Co. Kildare Library, Newbridge, Co. Kildare

Road Safety Audit
Stage 1 Report

Kildare County Council

Project number: 60669624
RSA 1

Problem: 4.1.1

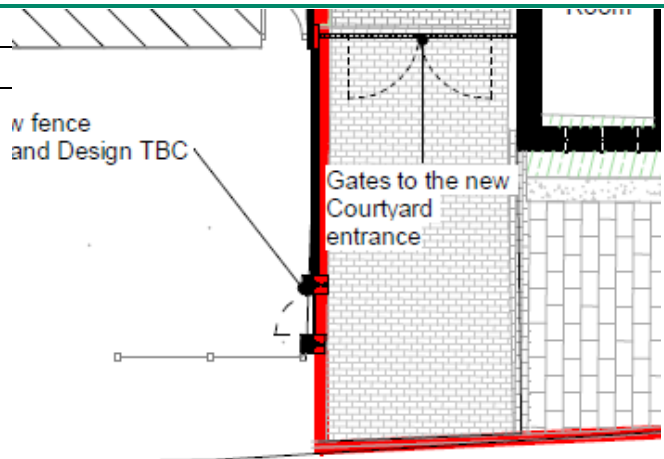
Summary: Uncontrolled junction tactile paving is indicated at controlled signalised crossings

The blister tactile paving layout proposed around the radius on the Main Street and Athgarvan Road junction is used at uncontrolled pedestrian crossing points. This junction is currently a signalised junction with a single crossing point on the radius with the appropriate associated controlled crossing tactile paving installed and a pedestrian call button for a 2-stage signalised pedestrian crossing.

The proposal shows two separate crossing locations for Main Street and Athgarvan Road. If this junction is remaining as a signalised junction then the proposed tactile paving at the new crossing locations shown do not have a stem to the back of the footpath, as required with a controlled crossing.

At a signalised pedestrian crossing, if the stem of the tactile paving does not extend to the back of the footpath or to the building line, there is a risk of the visually impaired missing the intended crossing point. This could lead to the visually impaired trying to cross the road at locations where it is unsafe to do so and colliding with vehicles on the carriageway.

Provide tactile paving at pedestrian crossing points appropriate to the crossing type.

Problem: 4.1.2

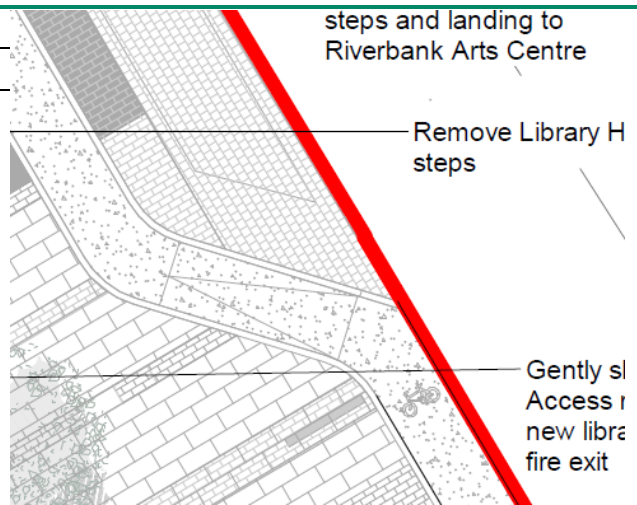
Summary: Lack of definition of priorities across shared surfaces can lead to pedestrian collisions.

The car park for the library is accessed from the Athgarvan Road. An access route has been identified but it is unclear whether the vehicular access is at the same level as the adjacent footpaths, as no dropped kerb has been shown at the road carriageway edge.

A lack of definition across the vehicular access lane may lead to drivers thinking that vehicles have priority at this location and there is a risk that footpath users could collide with vehicles while crossing this access.

The design should clearly indicate that pedestrians have priority over vehicles. Provide a raised access so that there is no change in level to the pedestrian footway and a clear delineation of pedestrian priority.

Problem: 4.1.3

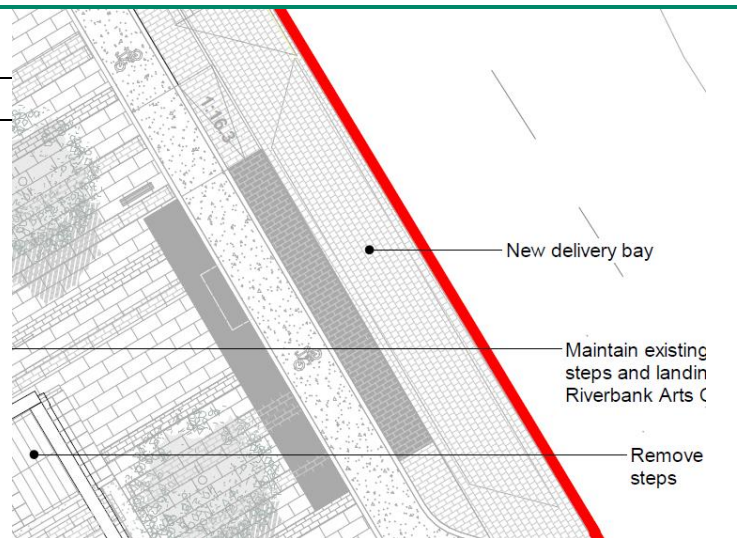
Summary: Risk of cyclists losing control due to geometry of cycle track, leading to falls

The cycle path along the frontage of the library on Main Street is being diverted to accommodate a proposed loading bay. The geometry of these radii of this uni-directional cycle route appears tight, particularly on the approach to a ramp. This could cause issues for cyclists, but in particular users on longer bicycles, such as recumbent, cargo or tandem bicycles. This can lead to cyclists losing control, particularly in wet conditions, which could lead to falls, resulting in cyclist injuries.

The proposed radii should be in line with the Nation Cycle Manual. Undertake swept path analysis on the proposed layout using different types of bicycle and that the design is appropriately amended, if required.

Problem: 4.1.4

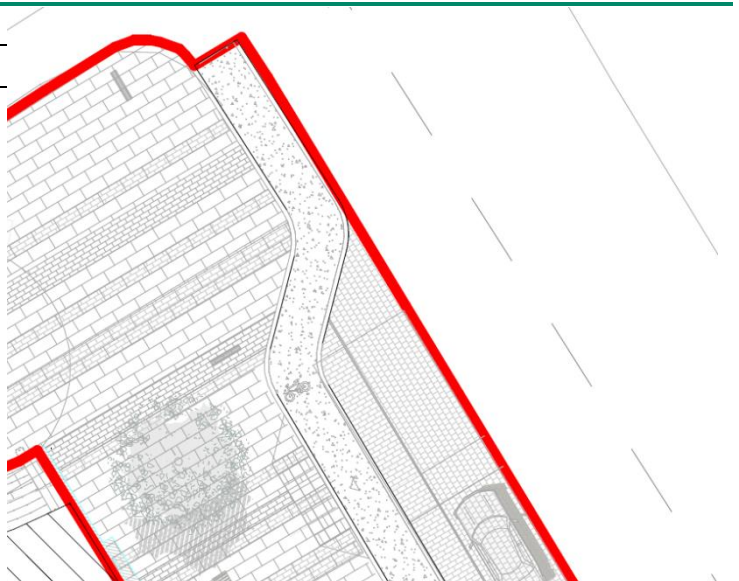
Summary: Risk of trip hazards and cycle path being blocked by loading bay equipment

A loading bay is proposed outside the library frontage on Main Street downstream of the signalised crossing. It is unclear how segregation of the cycle path from the footpath and loading bay is proposed, if an upstand is proposed either side of the cycle track to provide segregation cycle path or if road markings are to be used.

No provision of dropped kerbs are indicated on the drawings to allow access for delivery staff or wheeled delivery trollies across the cycle track onto the footpath or a raised crossing if upstand kerbs are provided both side of the cycle path. If insufficient segregation is provided between the loading bay and the cycle path, there is a risk of the cycle path being blocked by delivery vans which could lead to cyclists veering abruptly onto the carriageway resulting in collisions with vehicles on Main Street. A lack of appropriate crossing facilities from the loading bay can be a trip hazard and may lead to trips and falls by people travelling between the loading bay and footway which could result in personal injury.

Provide appropriate segregation from the loading bay and ensure that appropriate access is provided to delivery routes from the loading bay to the footpath.

Problem: 4.1.5

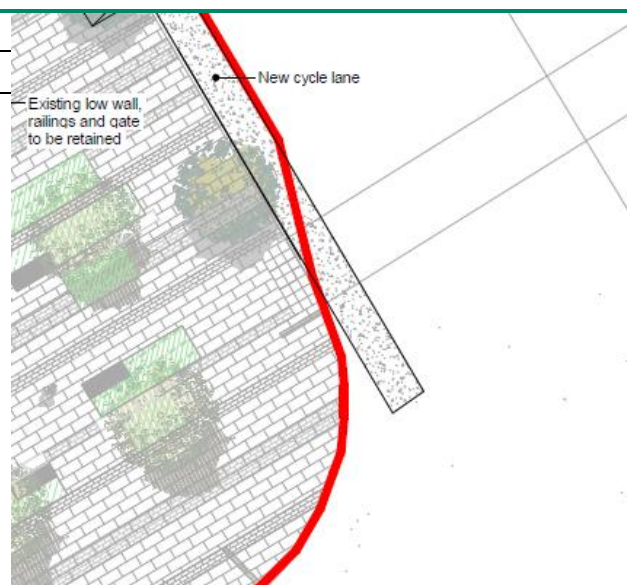
Summary: Risk of pedestrians sustaining personal injuries when attempting to transition between footway and bus boarding area due to lack of crossing across cycle track

A bus stop is located on Main Street outside the Riverbank Theatre. It is unclear if a street level or a raised crossing is provided across the uni-directional cycle track between the footway and the bus stop. If a raised crossing across the cycle lane is not provided, cyclists may understand that they have priority at this crossing location and there is a risk that bus users with mobility or visual impairments could collide with cyclists and sustain personal injuries whilst attempting to transition from the footway to the bus stop.

Provide appropriate infrastructure to enable all footpath users to transition safely between the footway and bus stop.
